E/ECE/324
E/ECE/TRANS/505 } Rev.1/Add.12/Rev.3/Amend.2

Addendum 12: Regulation No. 13

Revision 3 - Amendment 2

UNIFORM PROVISIONS CONCERNING THE APPROVAL OF VEHICLES OF CATEGORIES M, N AND O WITH REGARD TO BRAKING

Diagram 1.

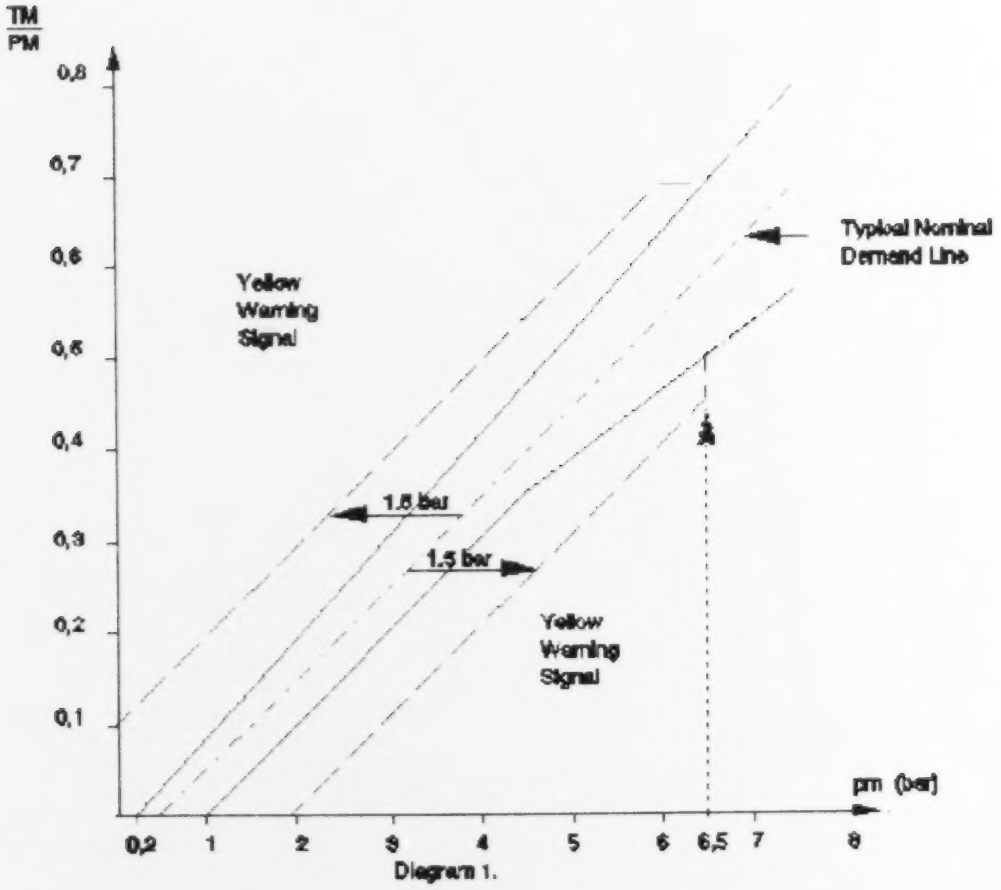
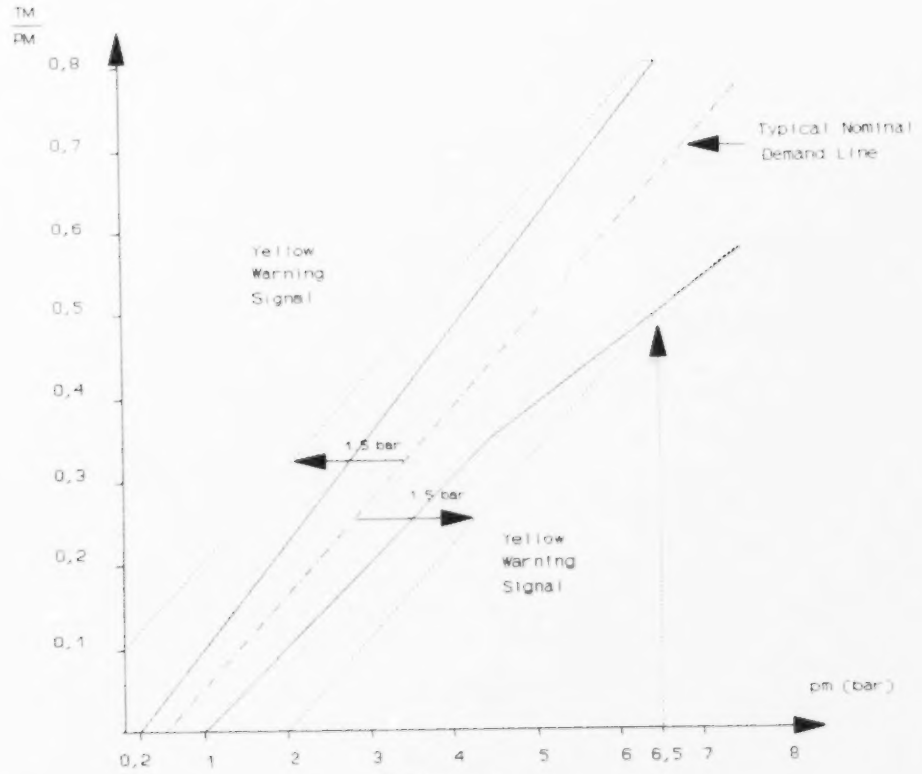
5.2.1.28.4. A coupling force control failure shall be detected and indicated to the driver by a yellow warning signal such as that specified in paragraph 5.2.1.29.1.2. In the event of a failure the relevant requirements of annex 10 shall be fulfilled.

5.2.1.28.5. Compensation by the coupling force control system shall be indicated by means of the yellow warning signal specified in paragraph 5.2.1.29.1.2. if this compensation exceeds ± 1.5 bar away from the nominal demand value defined in paragraph 2.27.3. up to a limit, in p_m, of 6.5 bar (or the equivalent digital demand). Above the level of 6.5 bar the warning shall be given if the compensation causes the operating point to lie outside the laden compatibility band as specified in annex 10 for the motor vehicle.

Figure 8: HYDRAULIC-TRANSMISSION BRAKING SYSTEM

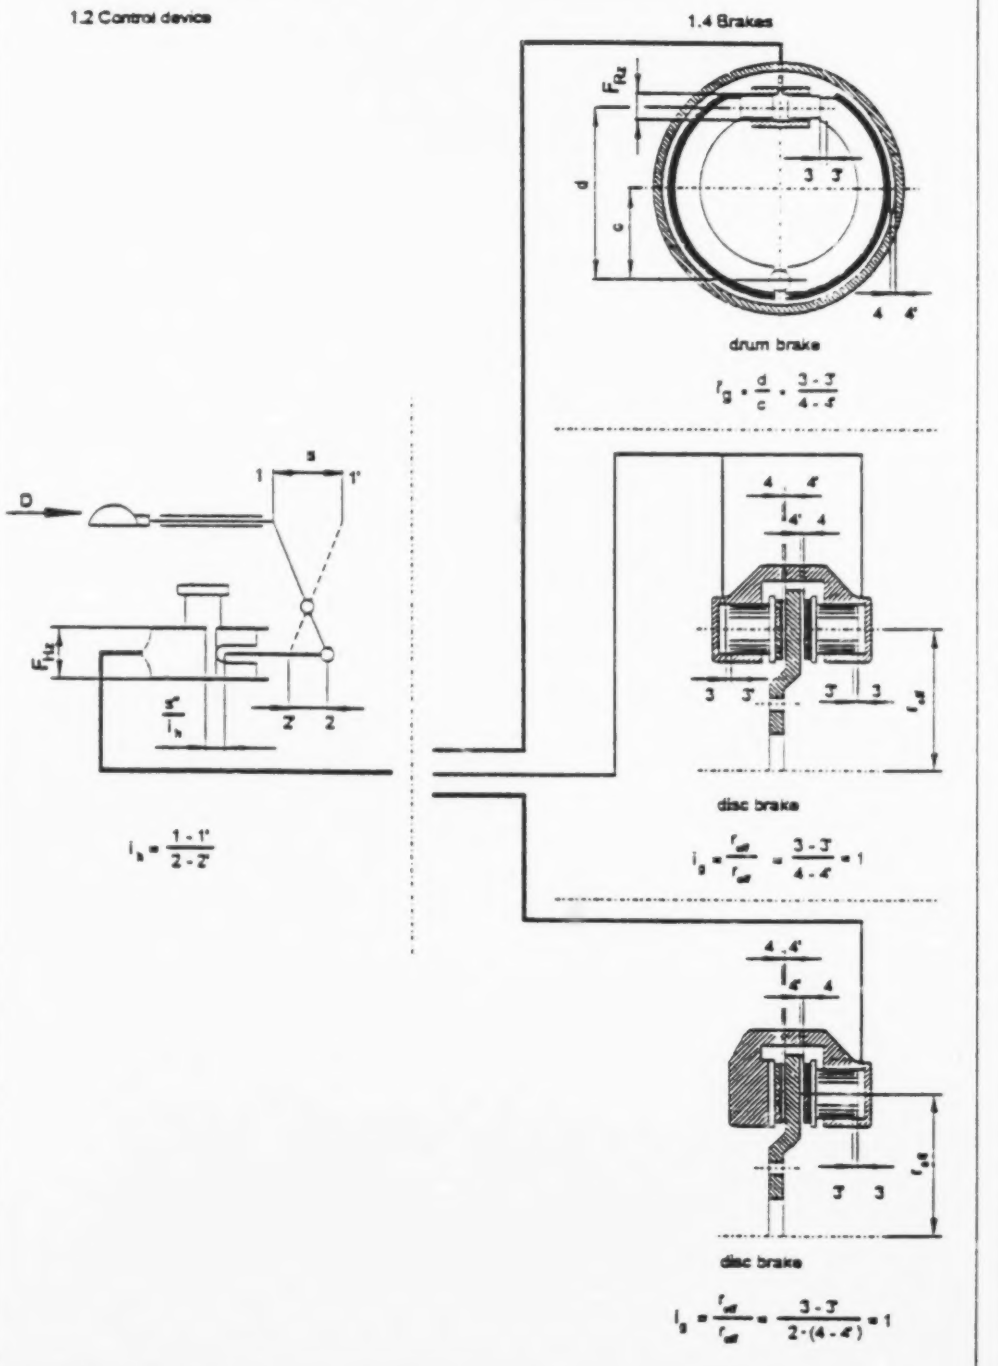
Figure 8 of appendix 1, replace by the following figure:
